# VILLAGE OF ORLAND PARK

### Plan Commission

Tuesday, March 5, 2019

[2018-0742](#) Ashburn Baptist - Teen Addition - Development Petition for Rezoning, Site Plan, Elevations, Landscape Plan, Special Use Permit

SHEET NUMBER:  
**SD101**

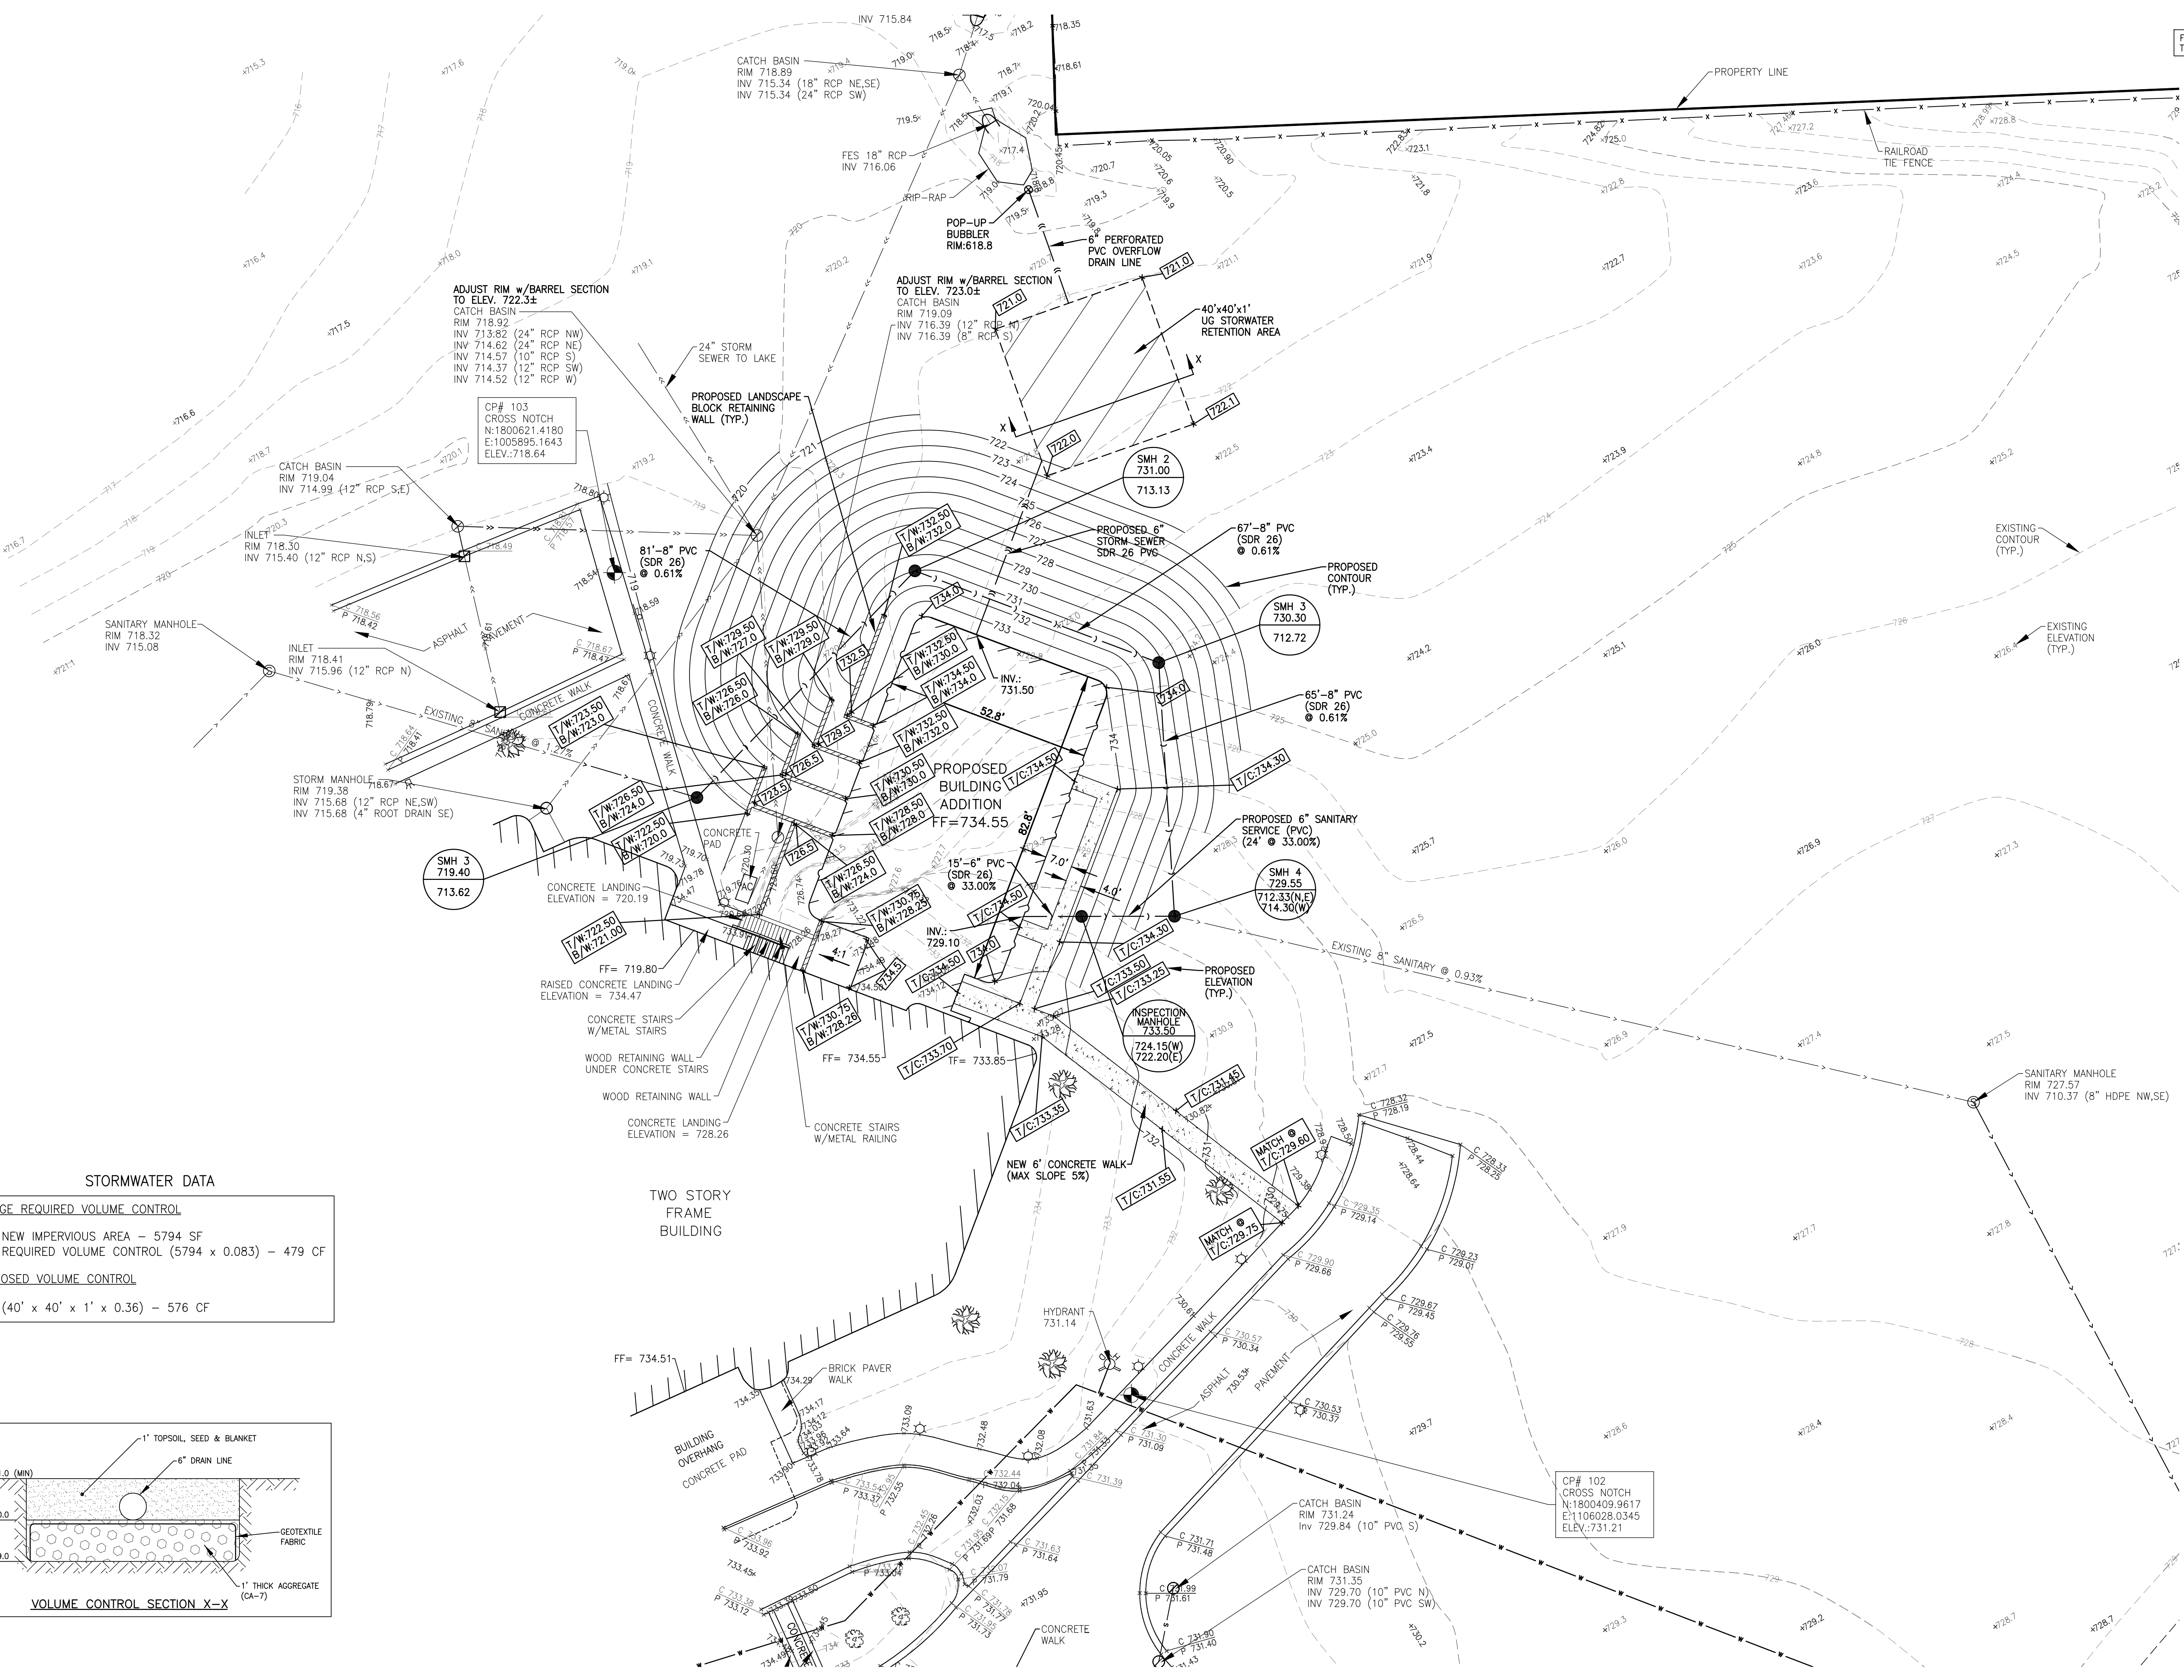
"I move to recommend to the Village Board of Trustees approval of the overall **Site Plan** titled "Preliminary Site Plan", by Carlson Architecture, project 18007, sheet number SD101, dated 10.19.2018; and on the site plan titled 'Preliminary Engineering Plan" by Carlson Architecture, project 18007, sheet number SD101, revised 1.14.19; and 'Landscape Plan' by Clarence Davis and Company, project # 19.1296.FV-sb, revised 1.23.19; and as shown on rooftop screening isometric titled "12-0049-4159" by CDI Crystal Distribution, page 1, dated 06.05.2018; and titled "**Elevations**", by Carlson Architecture, project 18007, sheet number A201, dated 10.19.2018, updated 01.14.19; and as shown on colored Elevations titled "Ashburn Baptist Church" by Carlson Architecture, dated Oct 19, 2018 with the following conditions:

1. Rooftop screening must match the proposed brick and trim color as closely as possible.
2. A Final Landscape Plan must be submitted for review and approval subject to the following condition:
  - a. Add at least 11 additional shrubs plus perennials along the northwest addition façade in the tiered foundation beds to meet Code.
3. Any new Signage will require separate Sign Permit approvals.
4. No new retaining wall shall exceed 3' in height.
5. Screen all new rooftop mechanicals from view.
6. Meet all final engineering and Building Division requirements.

SHEET NO. **A-3.2**

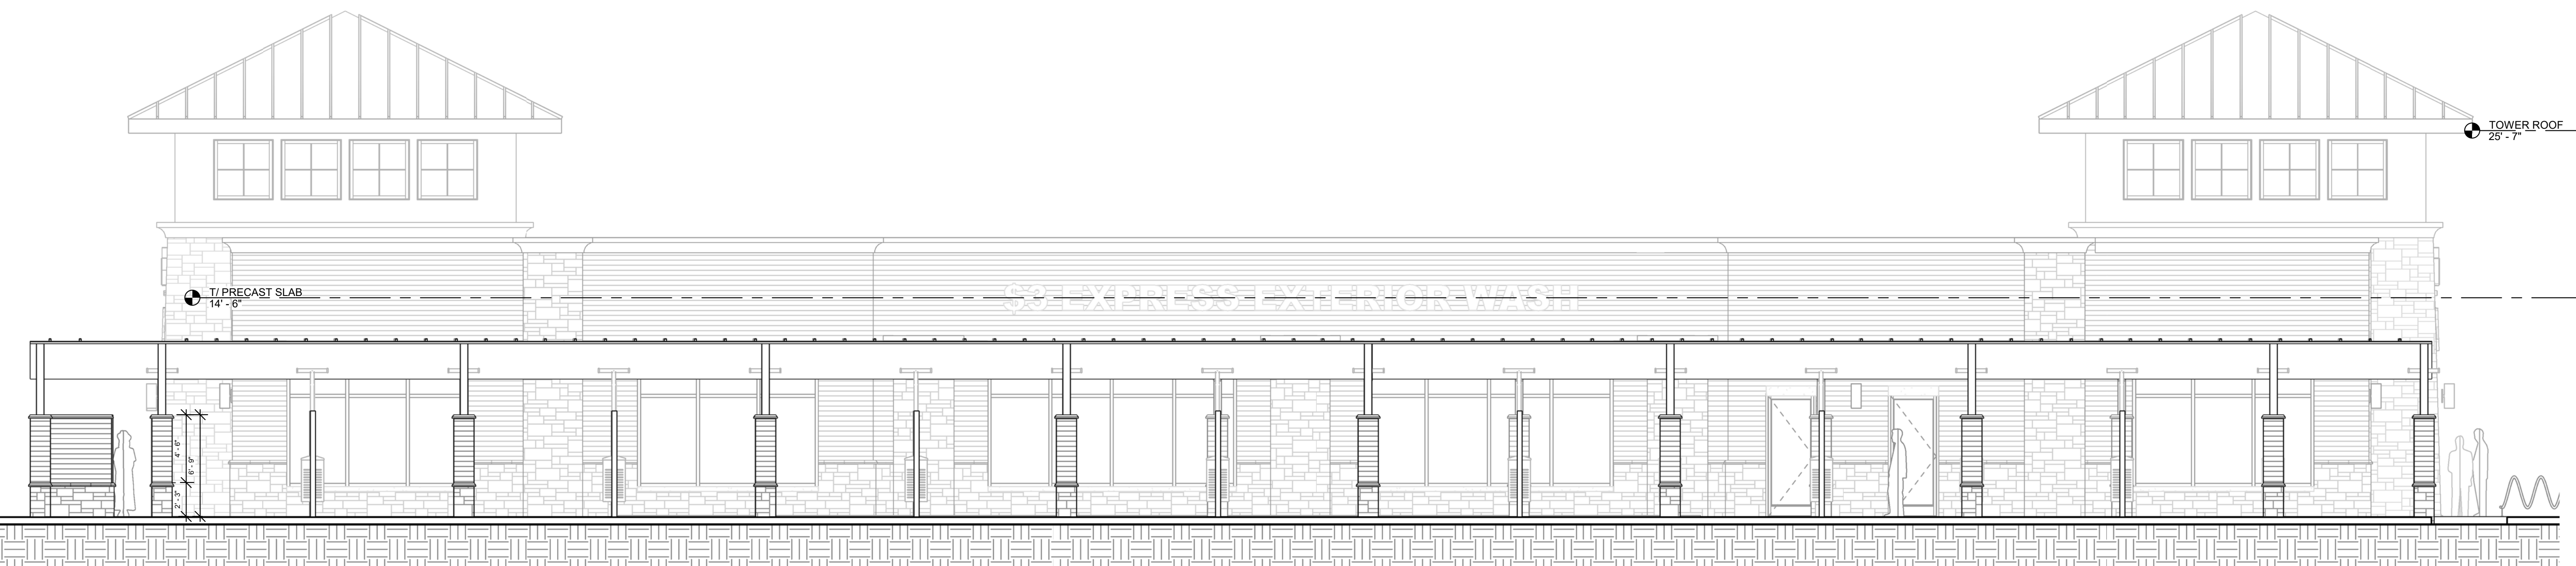
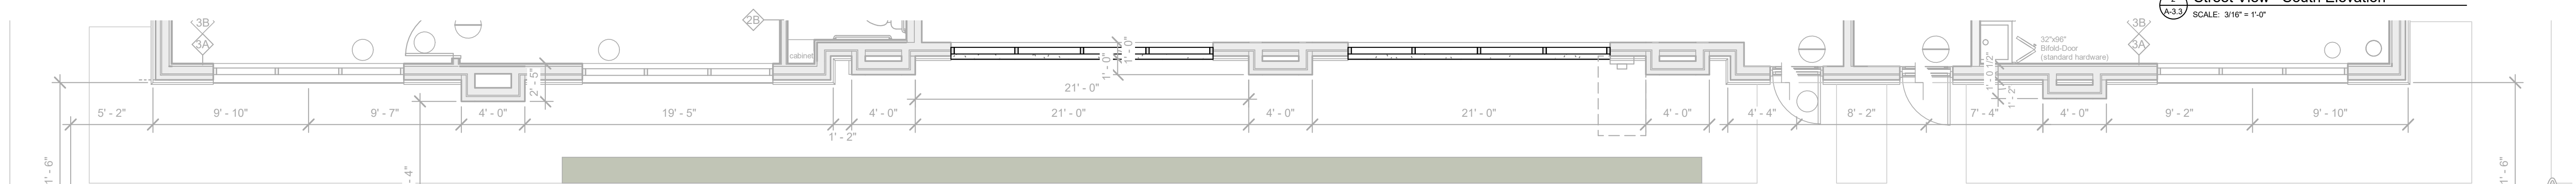
Garbage Enclosure - A garbage enclosure is proposed near the customer preparation loading area on the east side of the. As shown on the proposed elevations, Sheet A-3.2, the garbage enclosure will measure 9 feet 8 inches by 5 feet 8 inches, with an overall height of 6 feet 9 inches. It will be constructed of brick walls with a limestone base and brown louvered gates to match the materials and colors used on the building. As proposed, the garbage enclosure meets the requirements of the Land Development Code.
